# HBSA Comments

# Waste Standards

Public Works Committee – November 1, 2021

2 1430 MAIN STREET - PROPOSED HAMMERHEAD IMPACTS

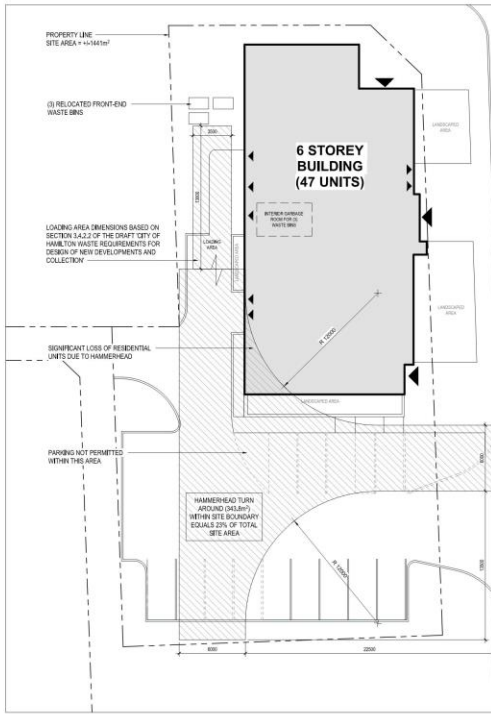
**SITE RESULTS DUE TO PROPOSED DRAFT HAMMERHEAD**

- SIGNIFICANT LOSS OF PARKING DUE TO HAMMERHEAD SPACE REQUIREMENTS (7 SPACES LOST)
- REDUCTION OF BUILDING AREA AND RESIDENTIAL UNITS DUE TO HAMMERHEAD SPACE REQUIREMENTS (MIN. 6 UNITS LOST)
- LOADING AREA IMPEDES EXISTING AND EGRESS AT THE REAR OF THE BUILDING
- GOALS FOR INTENSIFICATION WOULD BE REDUCED DUE TO PROPOSED HAMMERHEAD REQUIREMENTS

**TOTAL LOSSES:**

47 UNITS IS REDUCED BY 6 TO 41 UNITS BASED ON BUILDING AREA CLEAR OF HAMMERHEAD

13 PARKING SPACES IS REDUCED TO 7

REDUCTION OF PARKING MEANS FURTHER REDUCTION OF UNITS (BASED ON SECTION 5.6 OF BY-LAW 65-200 ASSUMING UNITS AS >50m<sup>2</sup>, AT 0.5 PER UNIT A FURTHER REDUCTION OF 14 UNITS OCCURS)

47 UNITS - 6 UNITS - 14 UNITS = 27 UNITS TOTAL

2 500 JAMES ST N - PROPOSED HAMMERHEAD IMPACTS  
1:200

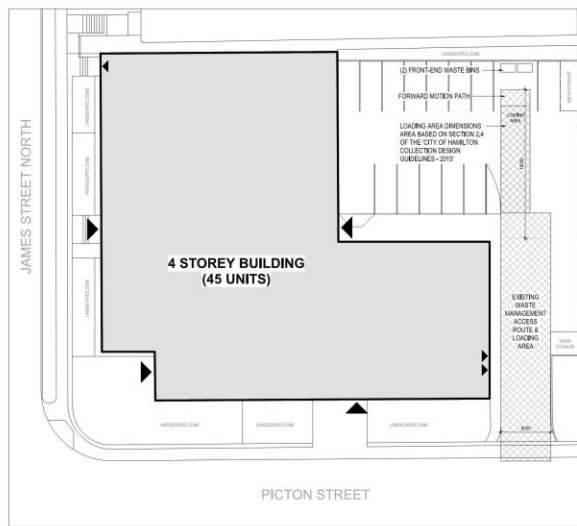
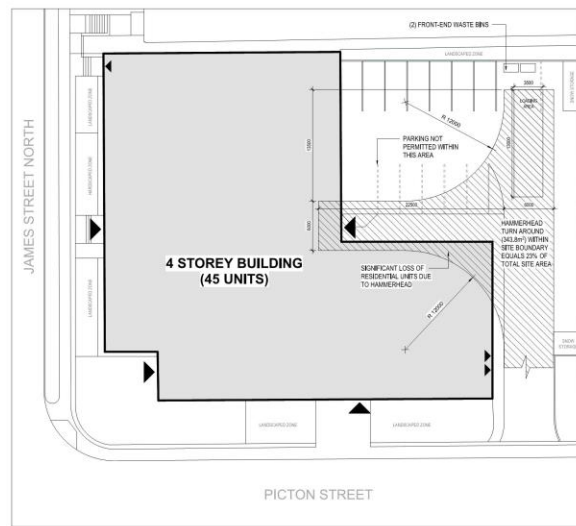
**SITE RESULTS DUE TO PROPOSED DRAFT HAMMERHEAD**

- SIGNIFICANT LOSS OF PARKING DUE TO HAMMERHEAD SPACE REQUIREMENTS
- REDUCTION OF BUILDING AREA AND UNITS DUE TO HAMMERHEAD SPACE REQUIREMENTS
- GOALS FOR INTENSIFICATION WOULD BE REDUCED DUE TO PROPOSED HAMMERHEAD REQUIREMENTS

**TOTAL LOSSES:**

45 UNITS IS REDUCED TO 41 UNITS BASED ON BUILDING AREA CLEAR OF HAMMERHEAD

16 PARKING SPACES IS REDUCED TO 7

REDUCTION OF PARKING MEANS FURTHER REDUCTION OF UNITS (BASED ON SECTION 5.6 OF BY-LAW 05-200 ASSUMING UNITS AS >50m<sup>2</sup> AT 0.5 PER UNIT A FURTHER REDUCTION OF 14 UNITS OCCURS)

45 UNITS - 4 UNITS - 14 UNITS = 27 UNITS TOTAL

2. 29 HARRIET - PROPOSED HAMMERHEAD IMPACTS  
1:100

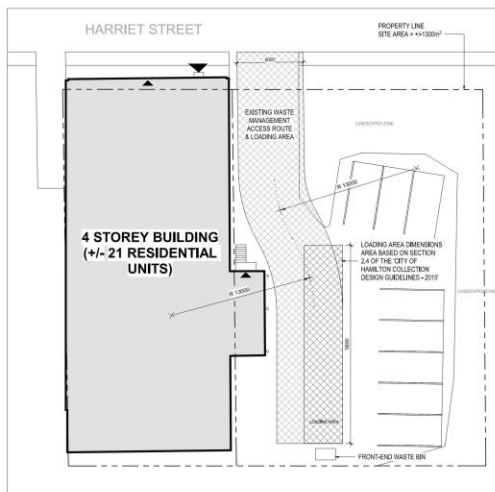
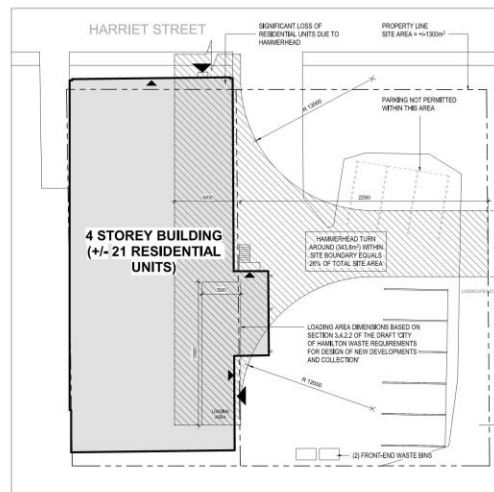
**SITE RESULTS DUE TO PROPOSED DRAFT HAMMERHEAD**

- THE CURRENT PARKING CONSTRAINTS WOULD ENCOUNTER SIGNIFICANT LOSS OF PARKING CAPACITY DUE TO HAMMERHEAD SPACE REQUIREMENTS
- REDUCTION OF BUILDING AREA AND UNITS DUE TO HAMMERHEAD SPACE REQUIREMENTS (12 UNITS LOST)
- GOALS FOR INTENSIFICATION WOULD BE REDUCED DUE TO PROPOSED HAMMERHEAD REQUIREMENTS

**TOTAL LOSSES:**

POTENTIAL FOR 21 UNITS IS REDUCED TO 9 UNITS BASED ON BUILDING AREA CLEAR OF HAMMERHEAD

MAJOR DEMOLITION TO EXISTING BUILDING WOULD BE REQUIRED

8 EXISTING PARKING SPACES IS REDUCED TO 5

1 SITE PLAN - Isabella (Ottawa)  
A0.07 E: 150

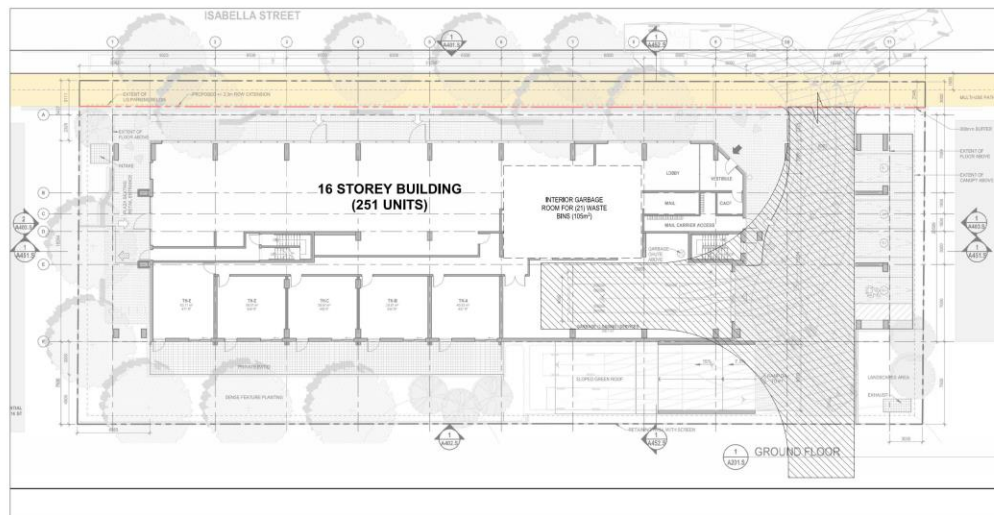
- LOSS OF UNITS AND OVERALL BL

- LOSS OF UNITS AND OVERALL BUILDABLE AREA DUE TO REQUIRED HAMMERHEAD
- LOSS OF UNITS DUE TO SPACE REQUIREMENTS FOR INTERIOR GARBAGE STORAGE
- PROJECT WOULD REQUIRE SIGNIFICANT REDESIGN IF PLANNED FOR THE CITY OF HAMILTON
